10 Mb/s Single Twisted Pair Ethernet 10BASE-T1L PHY Training Synchronization

Steffen Graber
Pepperl+Fuchs

PHY Control State Diagram Changes

PHY Control State Diagram Changes

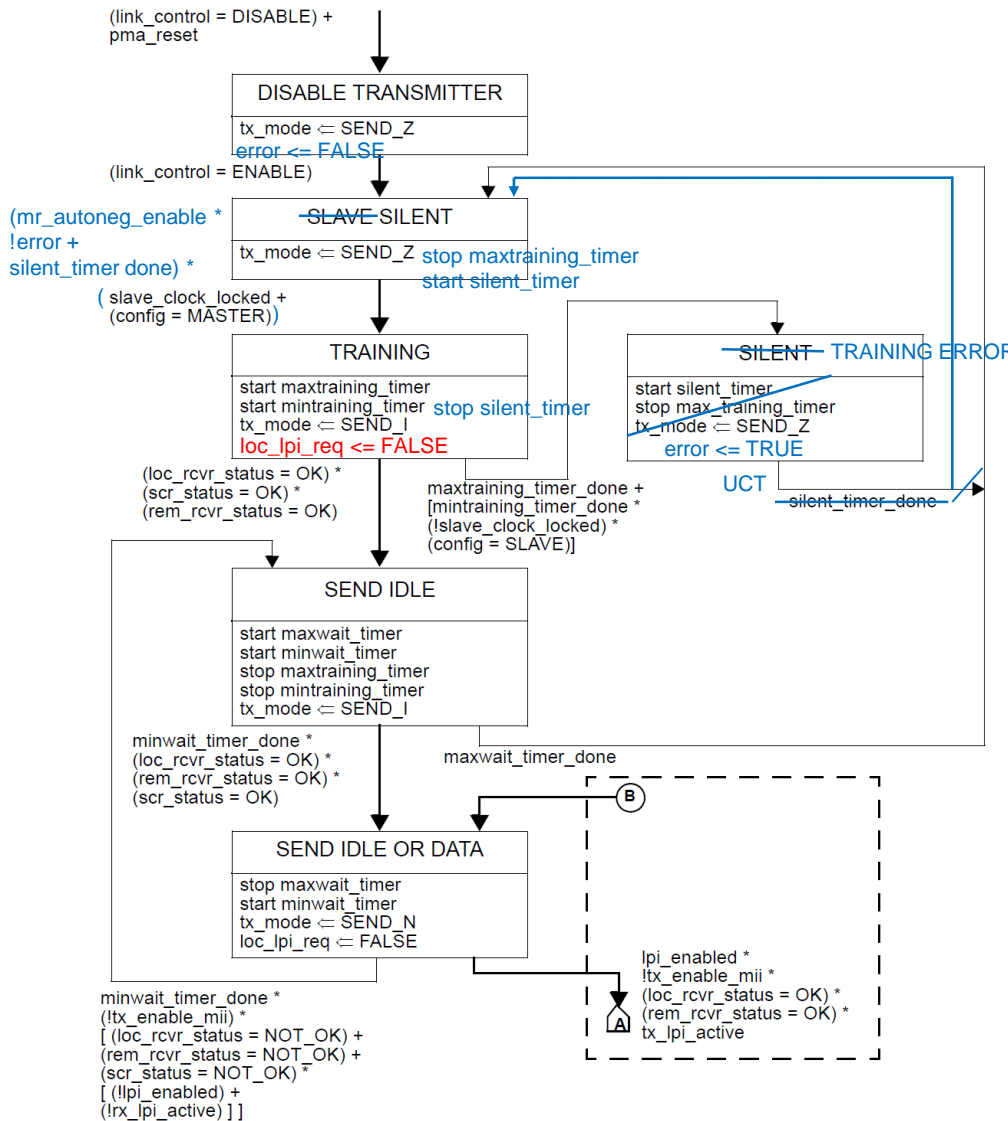
- The blue marked changes are necessary to mitigate the problem of synchronizing both PHYs during training, as described on the previous page (depending on if AN is enabled or not).
- Change the timer interval for the silent_timer from 100 ms ± 1 ms to 245 ms ± 5 ms to safely break the link.
- Add a new variable definition: `error`: This variable indicates, if an error during the link training occurred. Values: TRUE or FALSE
- Alternatively, Auto-Negotiation could be required as mandatory, but this would then be significantly different to other SPE PHYs, which are supporting force mode with optional Auto-Negotiation (so it may be preferable to keep it).
